RE: Completeness Review Letter for a Type III Site Design Review and Type III Conditional Use Permit for a new U-Haul storage and rental facility located within the Highway Commercial, C-2 zone of Cornelius.

Location: 2962 E Baseline Street
Cornelius, OR 97113

Below is a written response for the completeness review dated 07-21-23.

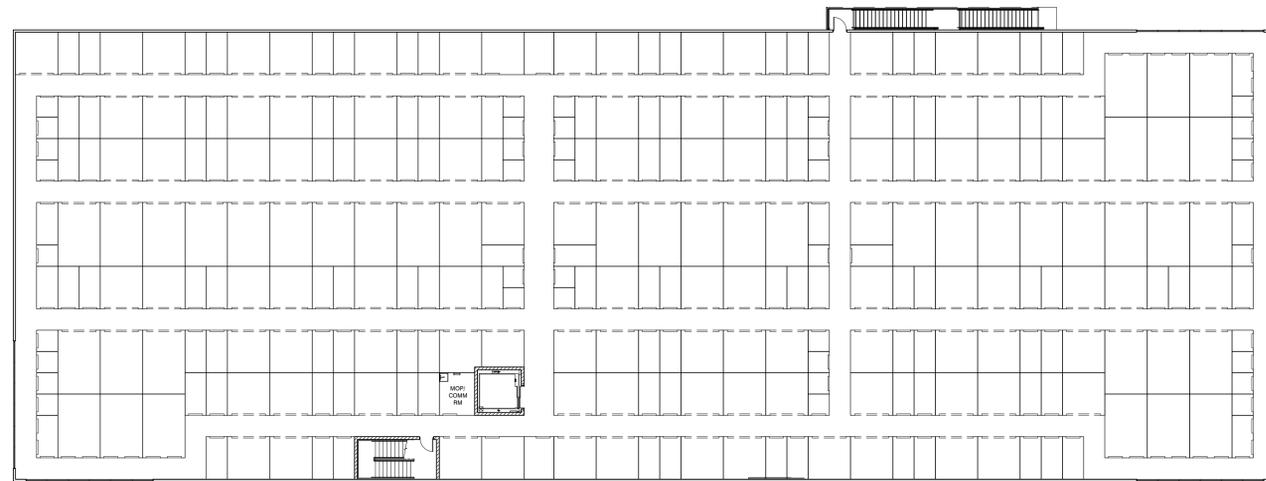
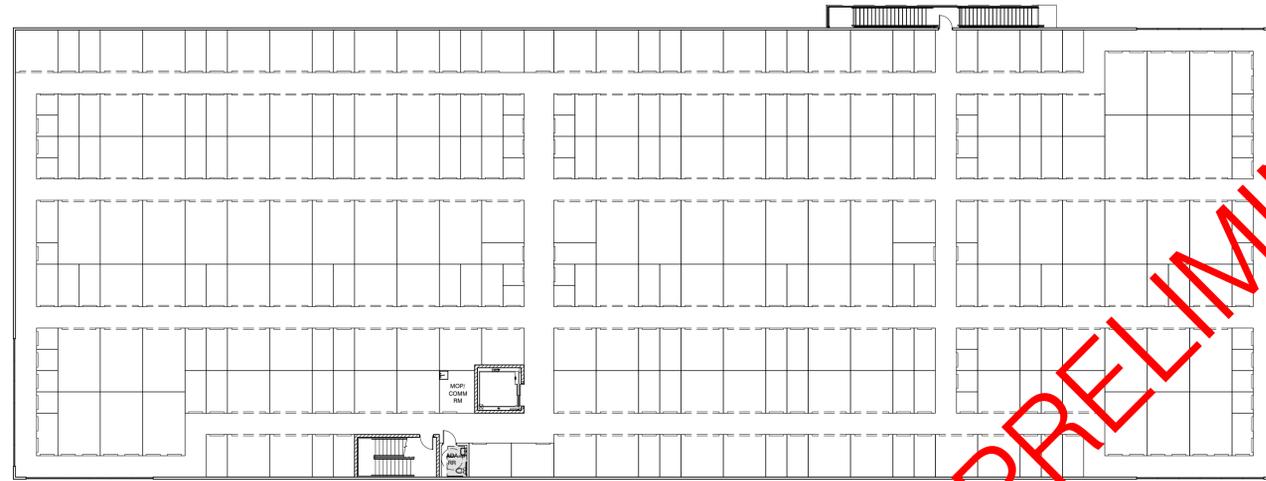
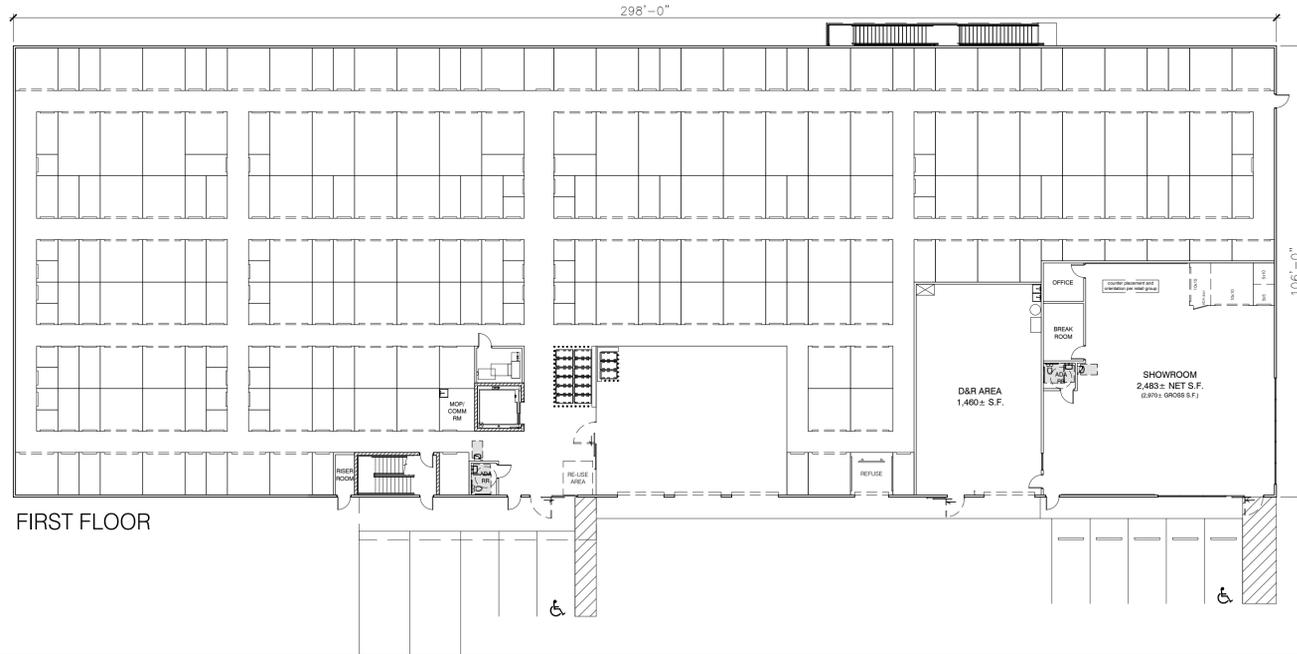
Comment 10: Provide detailed floor plans for each level of the building. Please include storage unit count for each floor.

Please refer to attached Floor Plan (A1.1) dated 04-17-23 including proposed storage unit mix table.
